SAFETY RECALL

Mack Trucks Inc.
Greensboro, NC USA

Date	Number	Release	Page
04.2015	SC0388	02	1 (7)

**Door Handle, Inside
LEU**

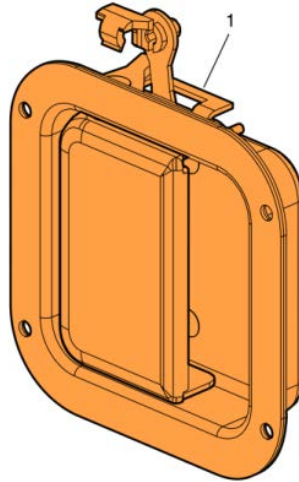
Because of stack-up tolerances, the actuator tab may be too short, which can allow the end of the actuator tab to slide behind the inner door latch. If this occurs, the driver may not be able to open the door from inside the truck, which under certain circumstances may increase the risk of injury. To reduce the potential risk of injury, replacement of the left and right inside door handles will be necessary.
